September 17, 1999

SUBJECT: PROPOSED RESOLUTION OF GENERIC SAFETY ISSUE-145, "ACTIONS TO REDUCE COMMON CAUSE FAILURES"

During the 465th meeting of the Advisory Committee on Reactor Safeguards, September 1-3, 1999, we reviewed the proposed resolution of Generic Safety Issue (GSI)-145, "Actions to Reduce Common Cause Failures." During our review, we had the benefit of discussions with representatives of the NRC staff. We also had the benefit of the documents referenced.

Yearly occurrence rate for complete CCF events, with 90 percent confidence band on the fitted trend.

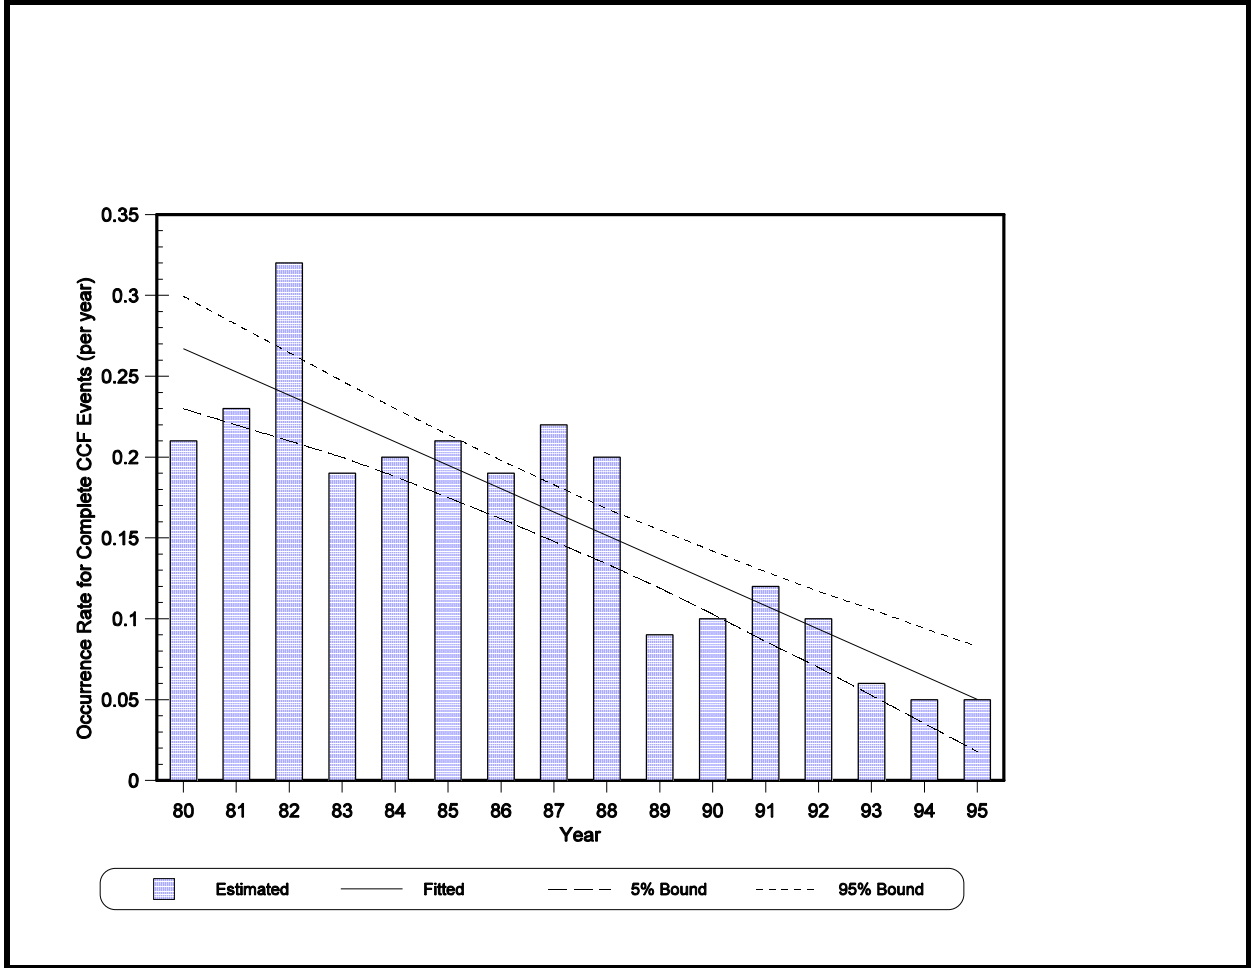
The efforts over the last 25 years to understand CCFs have been successful. The rate of occurrence of complete CCFs has been steadily decreasing (see attached Figure). Both the industry and the NRC staff have been sensitized to the significance of CCFs. A major contributor to this success has been the work sponsored by the former Office for Analysis and
